Product Change Notification / ALAN-27ZDFO664

CCB 6183 Initial Notice: Qualification of MTAI as an additional final test location for selected AT24xx, AT25xx, and 24FCxx device families available in 8L UDFN (2x3x0.6mm) package.

PCN# ALAN-27ZDF0664

Pin1 Orientation Quadrant in Tape and Reel

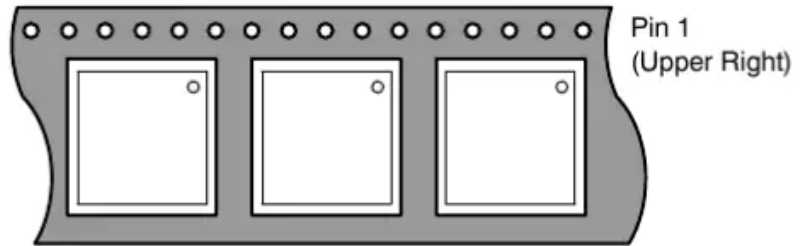
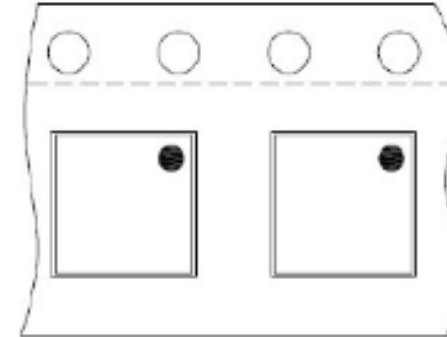
ANAP

Quadrant 2

MTAI

Quadrant 2

Carrier Tape (8L UDFN 2x3x0.6mm)

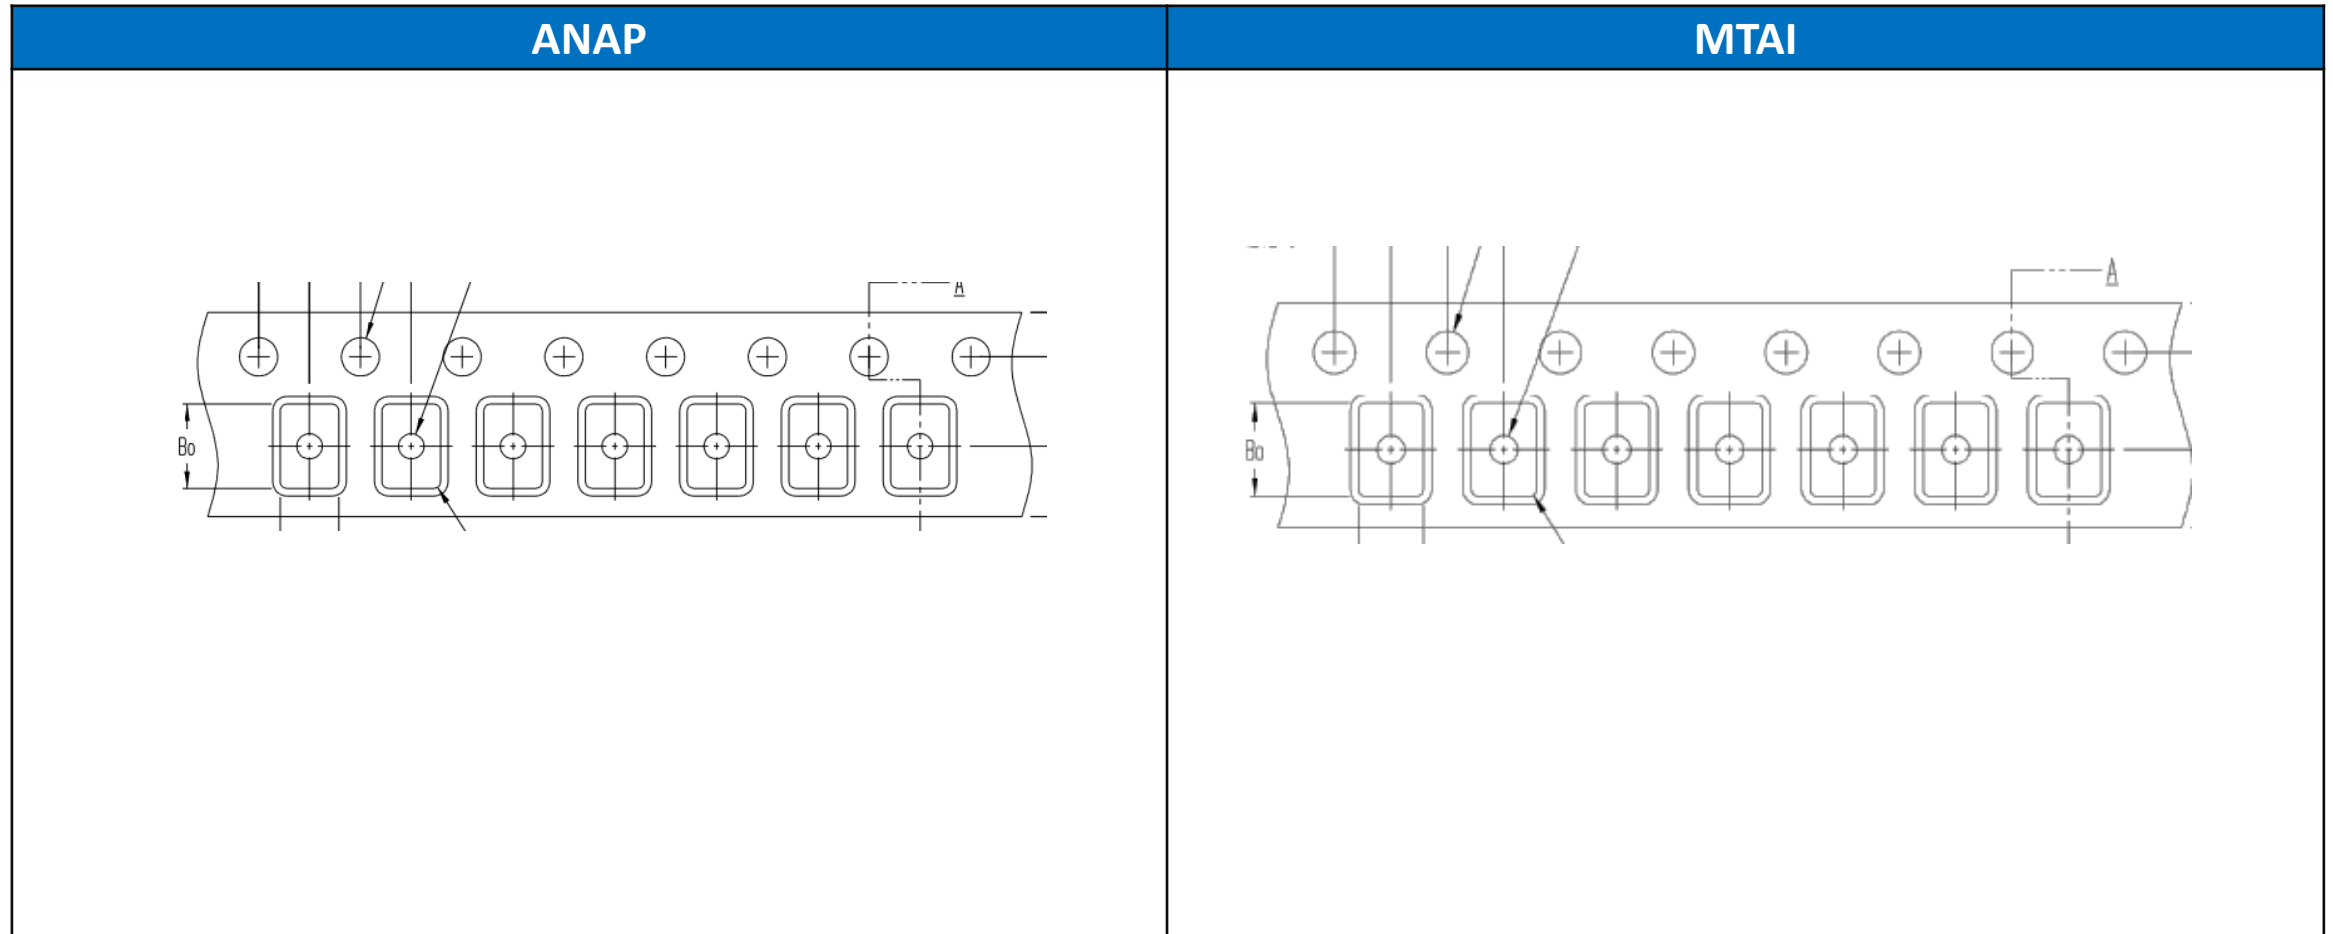
Plant	W (mm.)	P (mm.)	A0 (mm.)	B0 (mm.)	K0 (mm.)	Thickness (mm.)
ANAP	8.0 +0.3/-0.1	4.0 +/-0.1	2.30 +/- 0.1	3.30 +/- 0.1	0.75 +/- 0.1	0.30 +/-0.05
MTAI	8.00 +0.3/-0.1	4.00 ±0.1	2.30 ±0.1	3.30 ±0.1	0.75 ±0.1	0.30 ±0.05

Cover Tape (8L UDFN 2x3x0.6mm)

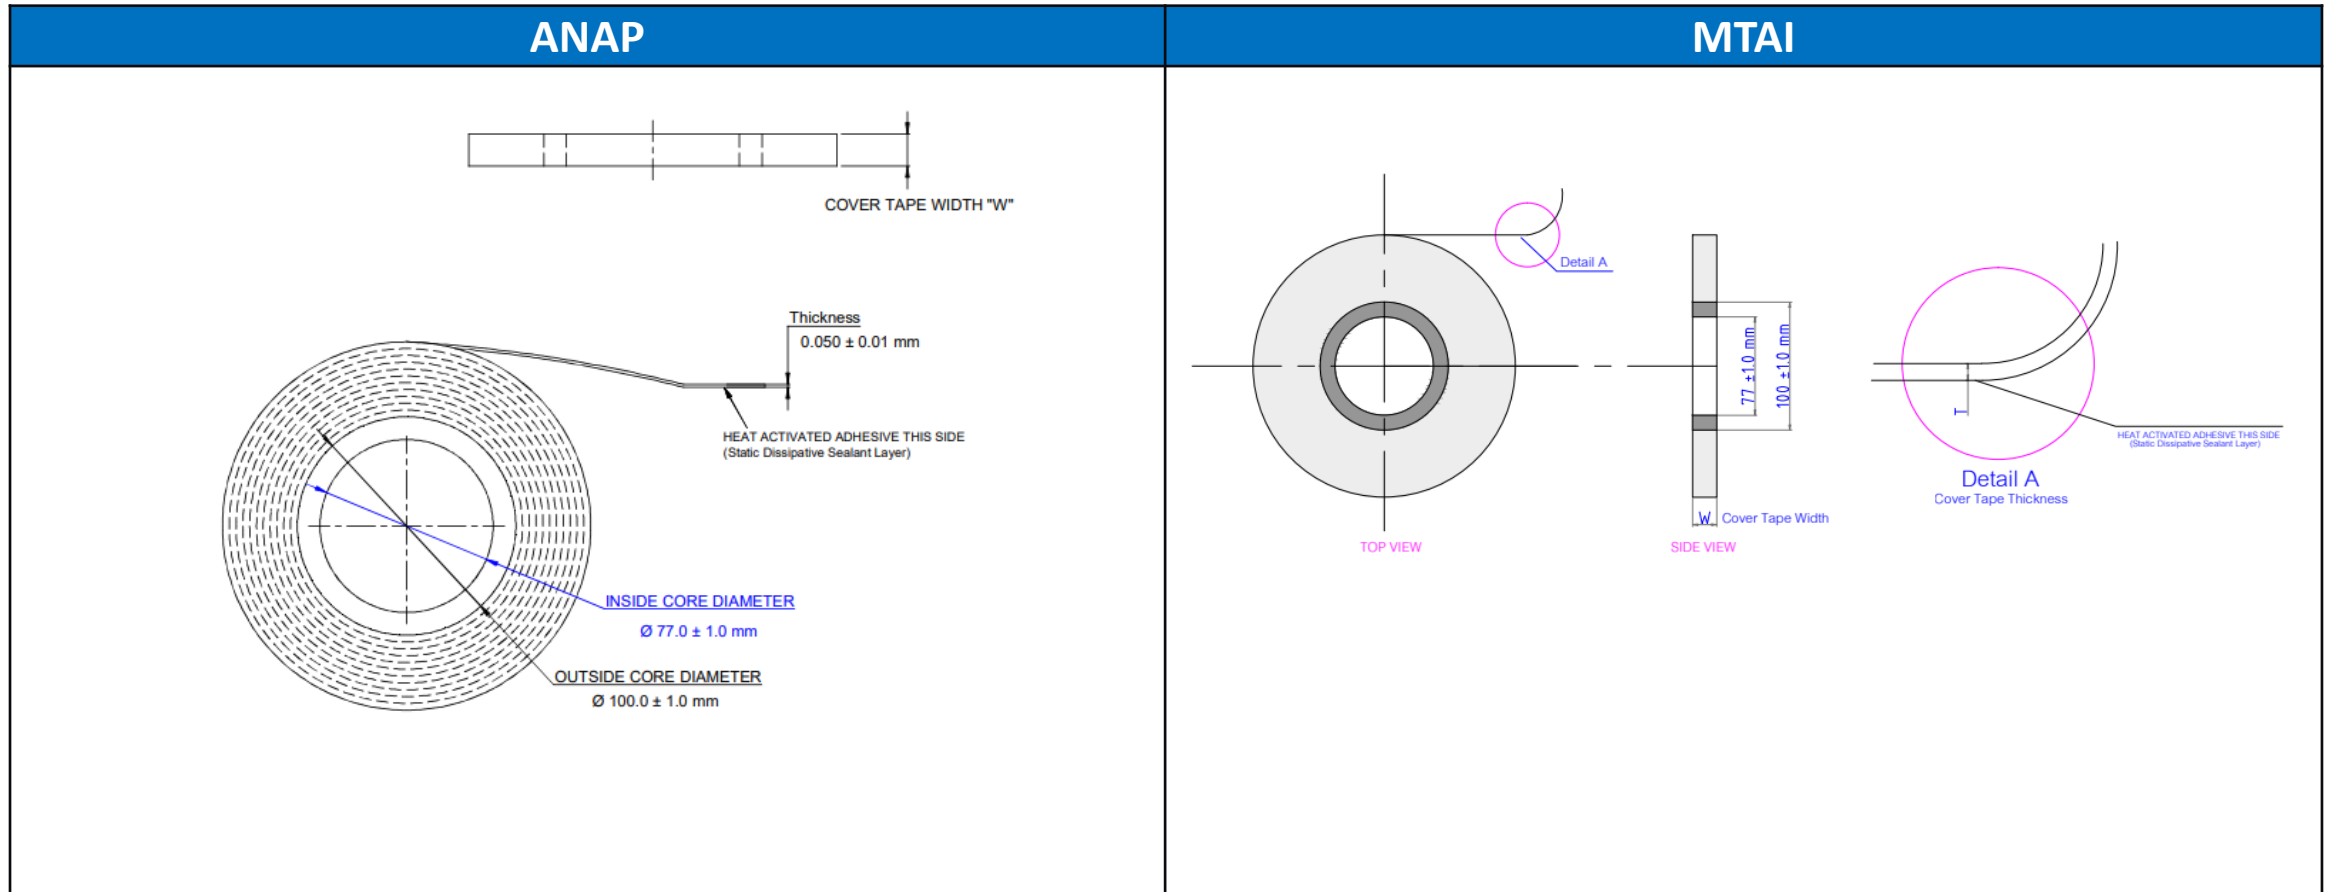
Plant	Width W (mm.)	Thickness T (mm.)	Colour	Sealing Methodology
ANAP	5.4 +/- 0.10	0.050 +/- 0.01	Gray	Heat Seal
MTAI	5.3 ±0.1	0.050 ±0.010	Clear	Heat Seal

Plastic Reel (8L UDFN 2x3x0.6mm)

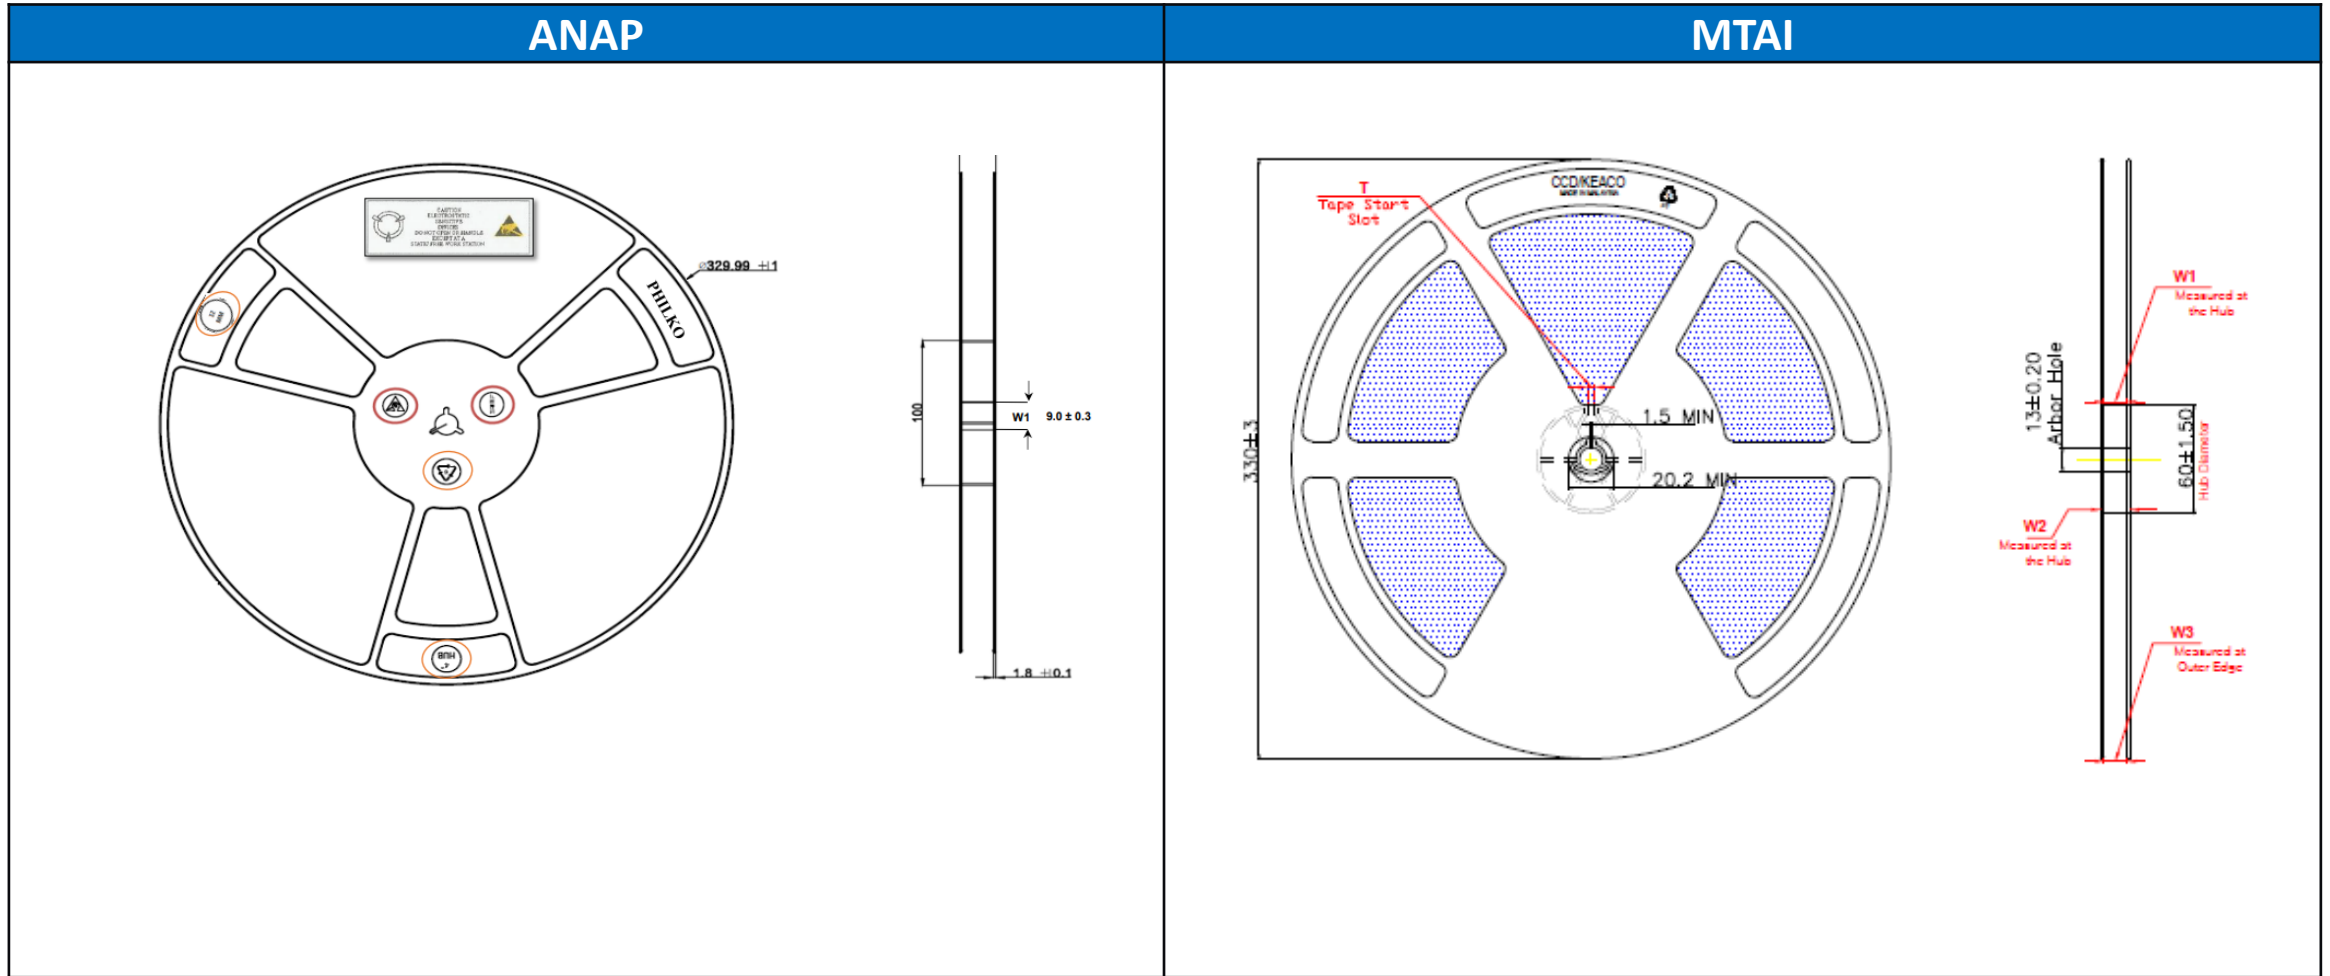
Plant	Supplier Part	Reel Diameter (mm.)	Reel Hub Size (mm)	Reel Width Max (mm.)	Colour
ANAP	PTC-PR0012-8	329.99 ± 1	100	11.4 ± 0.8	White
MTAI	91984-1	330 ± 3.0	60 ± 1.5	14.40	White

T/R Packing Static Sensitive Bag for Non dry Pack (MSL-1)

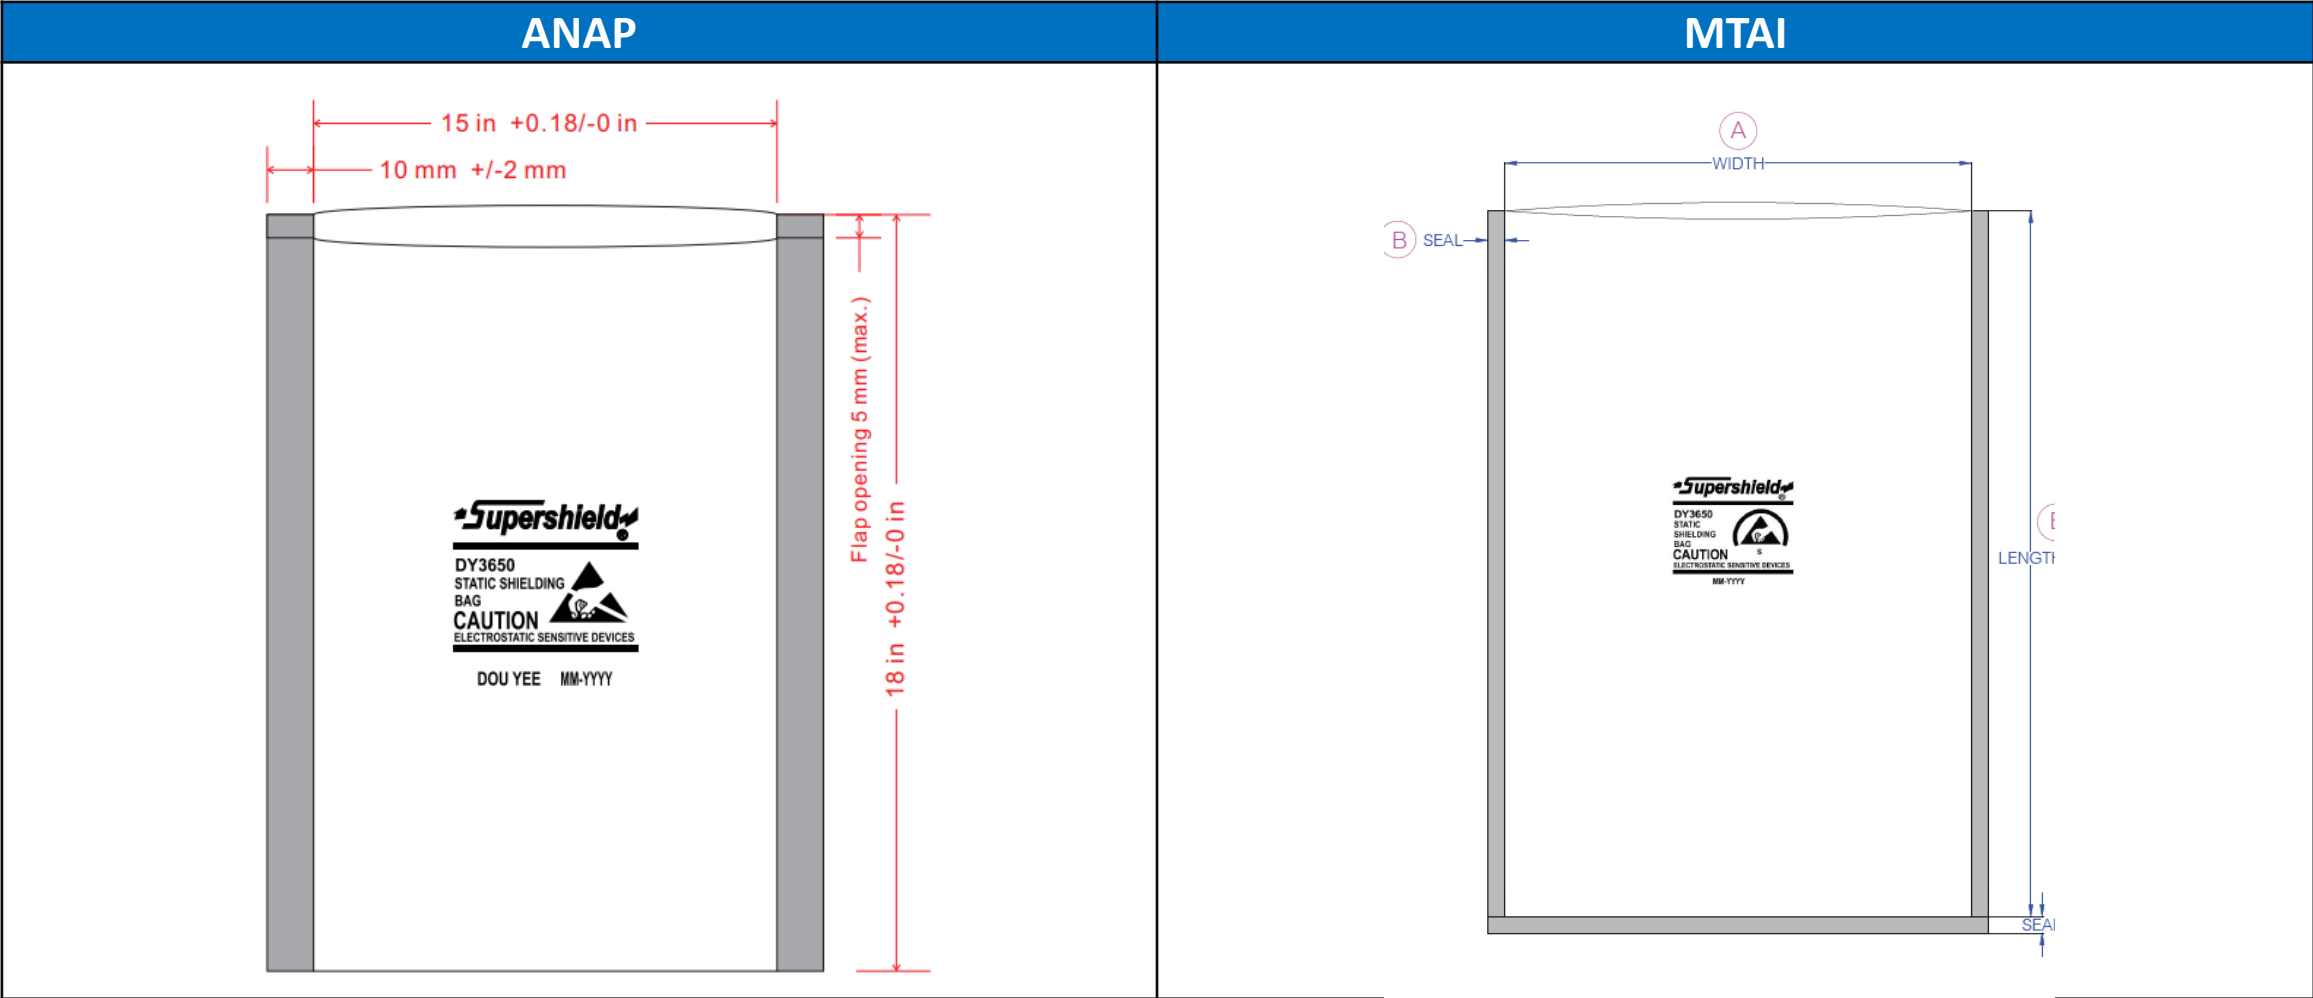
Plant	Length (mm)	Width (mm)	Thickness (mils)	Colour
ANAP	482.6 +4.5/-0	381 +4.5/-0	3.0 +/- 0.3	Gray
MTAI	420 +5/-0	370 +5/-0	3.0 ±0.3	Transparent

T/R Packing Method for Non dry Pack (MSL-1)

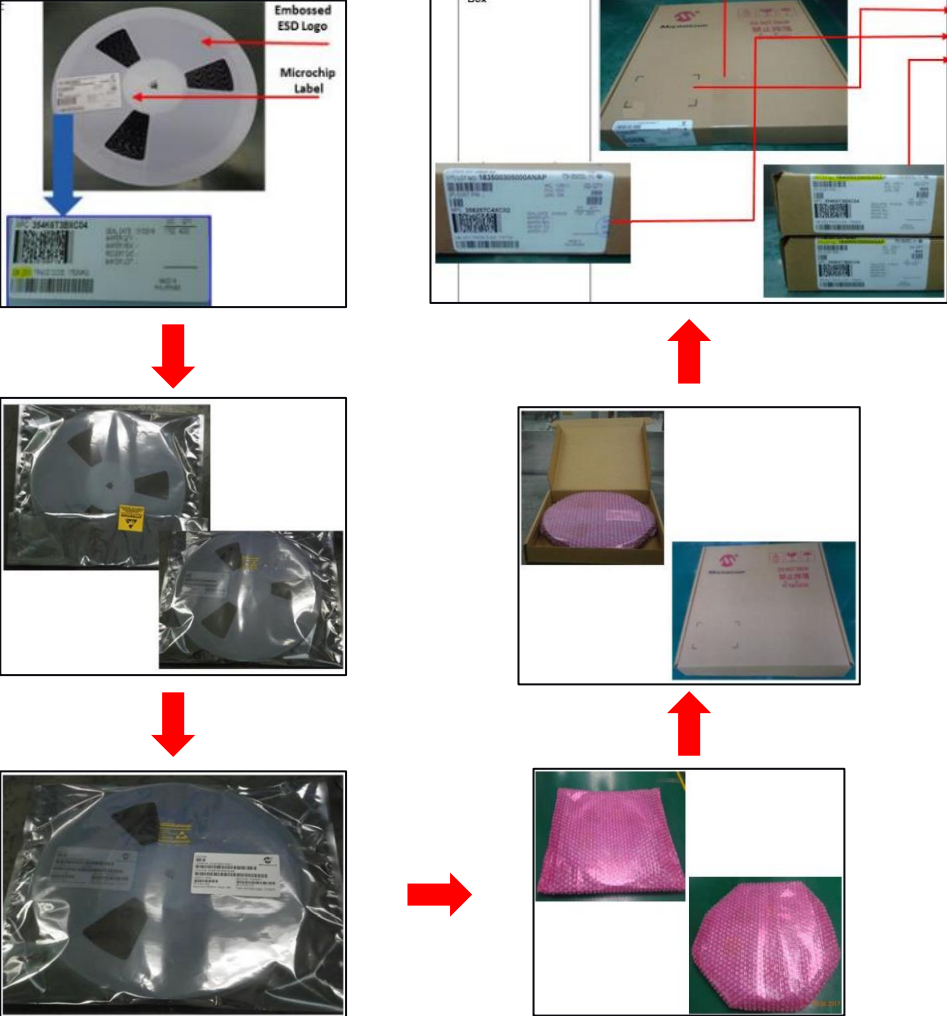
ANAP	MTAI												
 <p data-bbox="675 1285 1261 1320"><i>ANAP use inner box and outer box for shipment</i></p>	 <p data-bbox="1745 556 1949 592">No inner box</p> <p data-bbox="1286 614 2254 649">Carton for Packing and Shipping without inner box for product in T/R media (MSL-1)</p>
